Docket Item # 6
BAR CASE # 2008-0013

BAR Meeting
May 21, 2008

ISSUE: Alterations and Signage
APPLICANT: M. Catharine Puskar
LOCATION: 825 N. Washington Street
ZONE: CDX/Commercial

Figure 1. Existing Conditions/Lighting Plan

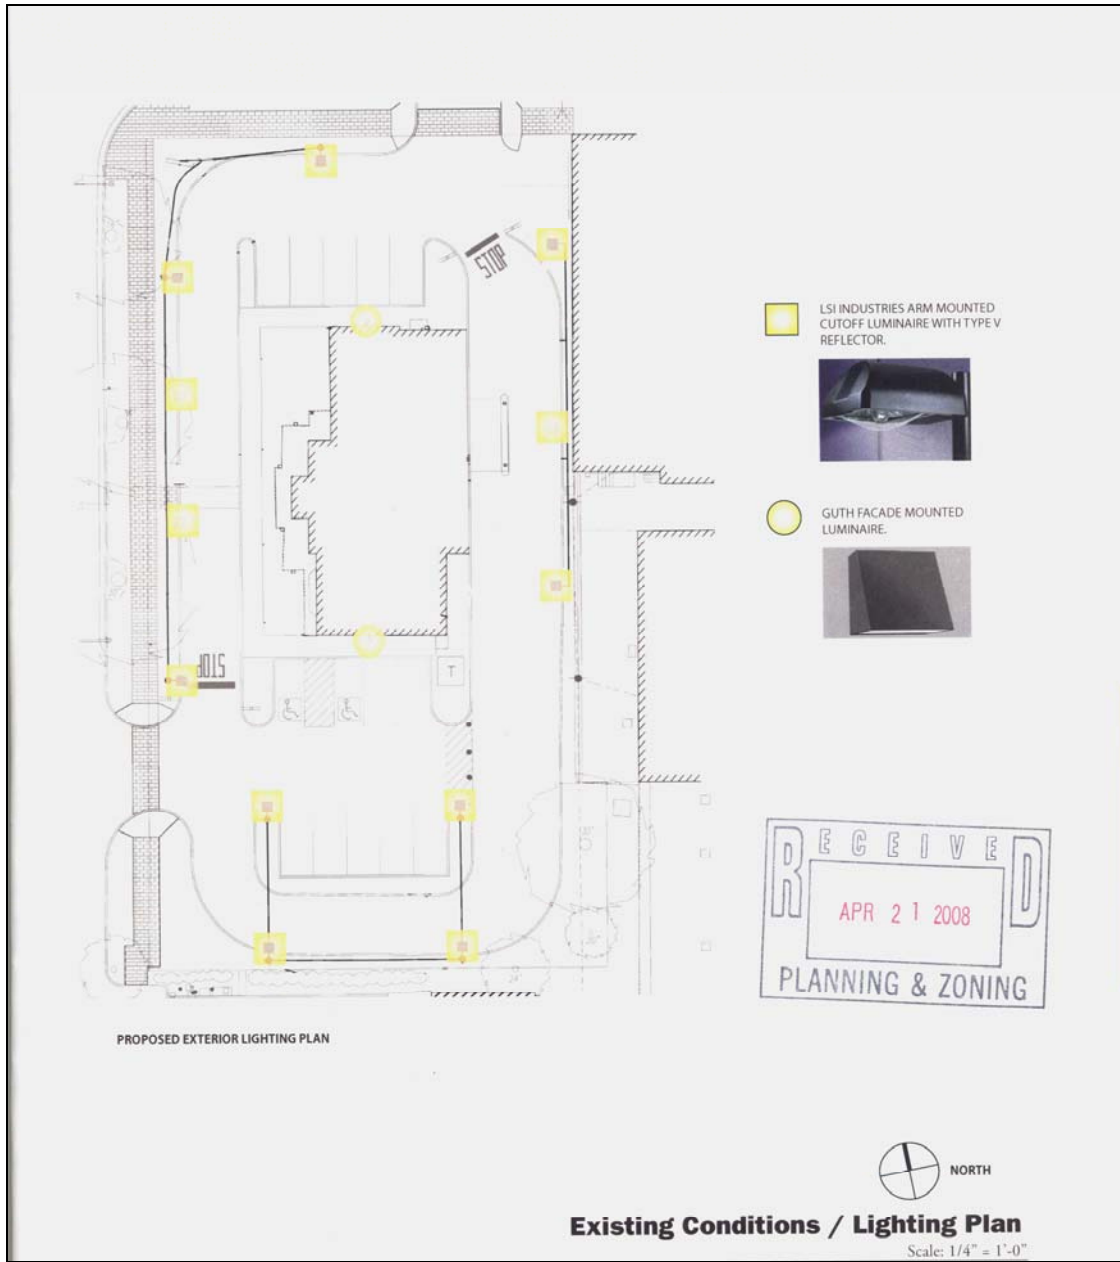
Due to its location along the George Washington Memorial Parkway, the manner and treatment of external lighting for this building is important. Staff remains concerned that the number of proposed freestanding poles is excessive, since the site currently has three poles with two light fixtures. Staff is also concerned that the lighting levels proposed by the applicant are too high, as well as the need for the two façade mounted downlights. Observations by staff of the current lighting conditions for the site show lighting levels measured at approximately one foot-candles at the brightest locations within the parking lot and drive area, such as at the driveway near the front entrance, and with much lower light levels in the south parking area. The submitted light plan shows light levels proposed to be approximately 3 - 4 foot-candles over most of the parking

lot and drive aisles, which would be at least three to four times the current site lighting levels. The submitted lighting plan also does not depict the can lighting that currently exists under the roof overhang along the front building wall. Additionally, staff believes that the lighting levels under the proposed drive-through canopy are excessive and should be reduced. However, Staff believes that these issues can be resolved with the applicant working with Staff to bring them into satisfactory conformance with City standards while reducing lighting levels by approximately 50% in comparison to the light levels proposed in the submitted plans.

- 1) That the applicant work with Staff to reduce the number of the freestanding poles and the light output levels so as not to exceed the minimum average lighting standards for the City of Alexandria;
- 2) That the applicant work with Staff to revise the lighting plan to include all exterior lighting fixtures such as pole lights on site, building mounted lighting installed in roof overhangs and soffits, and to include all public street lamps;
- 3) That the applicant extend display of photometrics to at least the centerline of adjoining streets; and,
- 4) That the proposed directional site signs be reduced in area to eliminate blank areas and to be only the size necessary to accommodate display of the proposed text.

Figure 3: Proposed Alterations

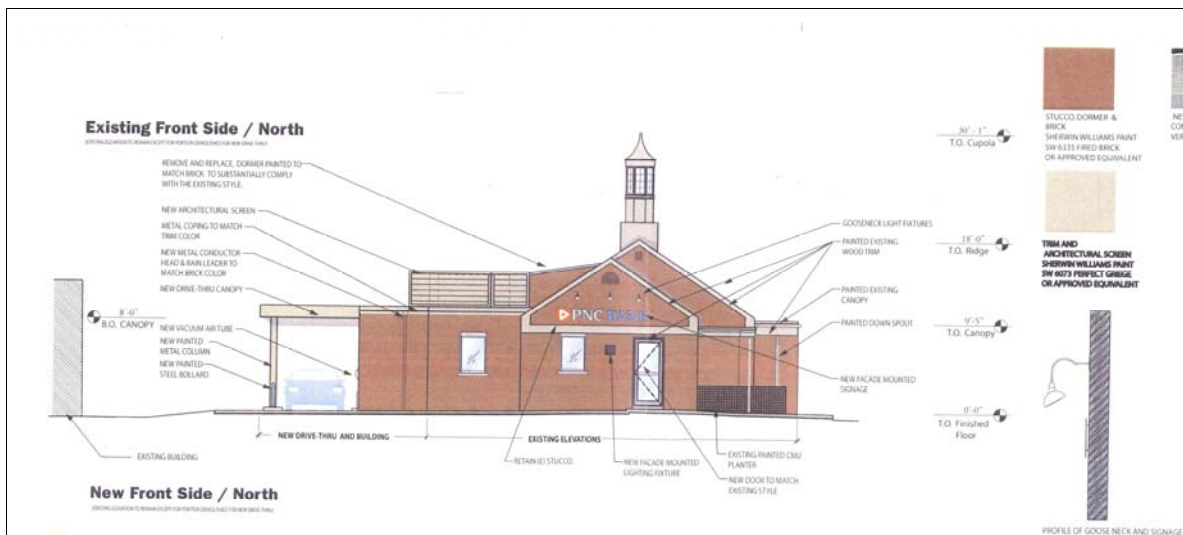
Staff supports the use of the gooseneck lights and the pin lighting in the soffit.

In response to the Board recommendations of approval on April 2, 2008, the applicant eliminated the PNC lettering and logo from the on-site directional signage. However, the signs were not reduced in size, resulting in the same size signs with large blank areas. Staff recommends that the signs be reduced in area to eliminate the blank space that previously supported the PNC corporate signage and to result in smaller signs.
